SERVICE No. 246 BULLETIN

Piper Aircraft Corporation

Subject: Modification of Oxygen Cylinder Rear Retaining Strap
Piper Part Number 758 109

Models Affected: PA-30 Twin Comanches (NOTE: Applicable only to
aircraft that have had an oxygen system installed at
the factory or aircraft that have had Piper Oxygen
Installation Kit 757 100 installed.)

SERVICE BULLETIN
246

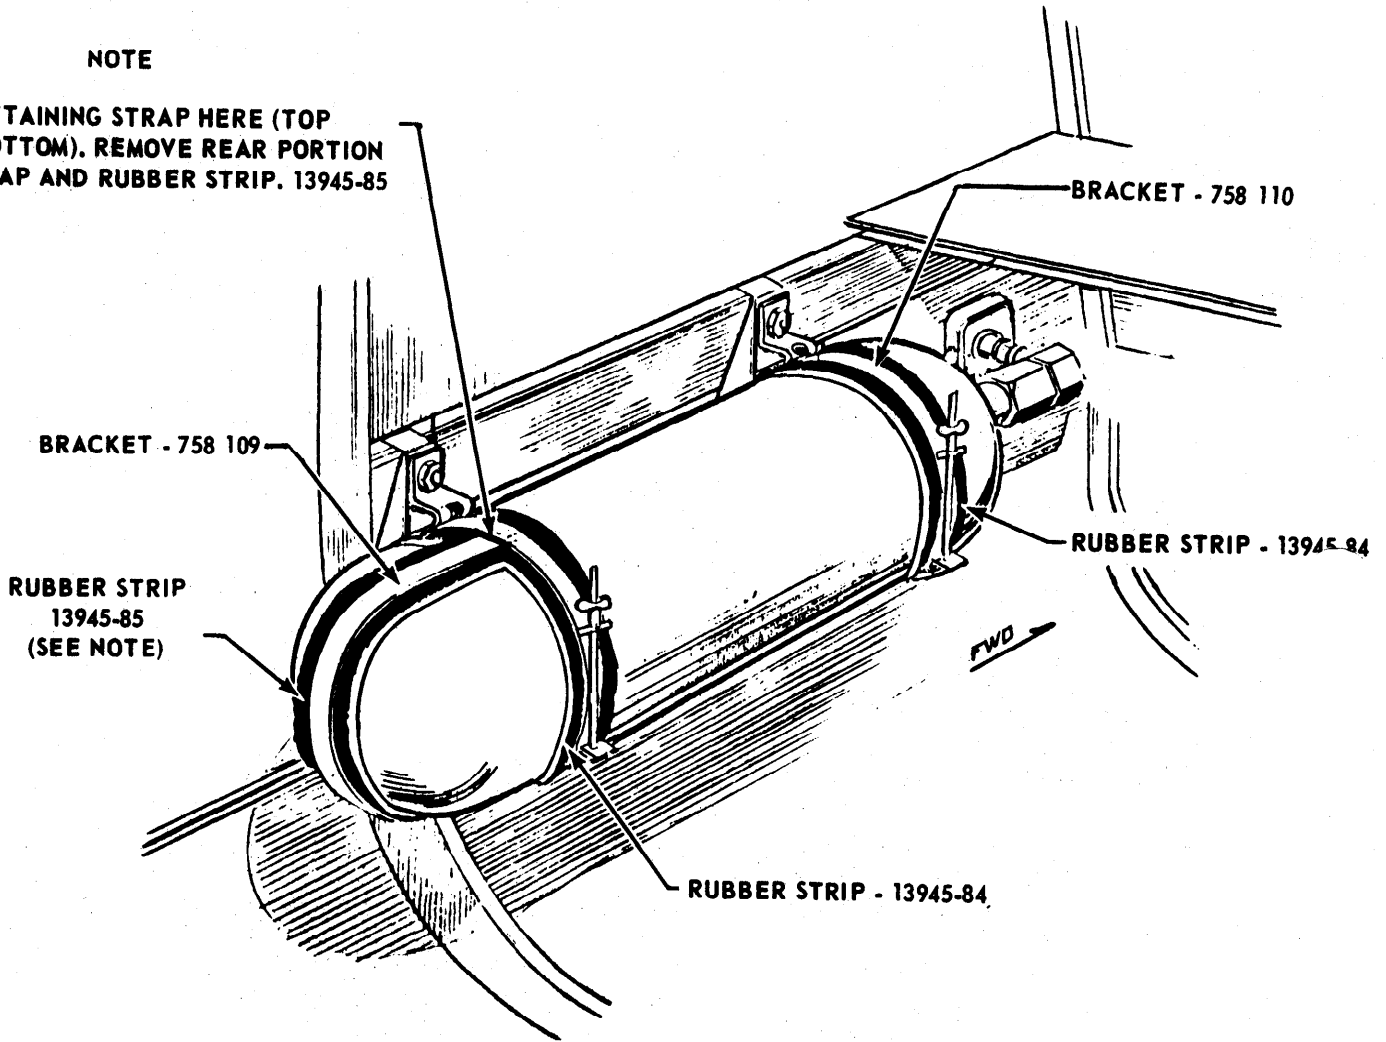
Reason For Bulletin: Modification of the oxygen cylinder rear retaining strap
part number 758 109 to preclude the possibility of the
strap rubbing the rudder control cable.

Modification Instructions: See sketch on reverse side of this bulletin.

CUT RETAINING STRAP HERE (TOP AND BOTTOM). REMOVE REAR PORTION OF STRAP AND RUBBER STRIP. 13945-85
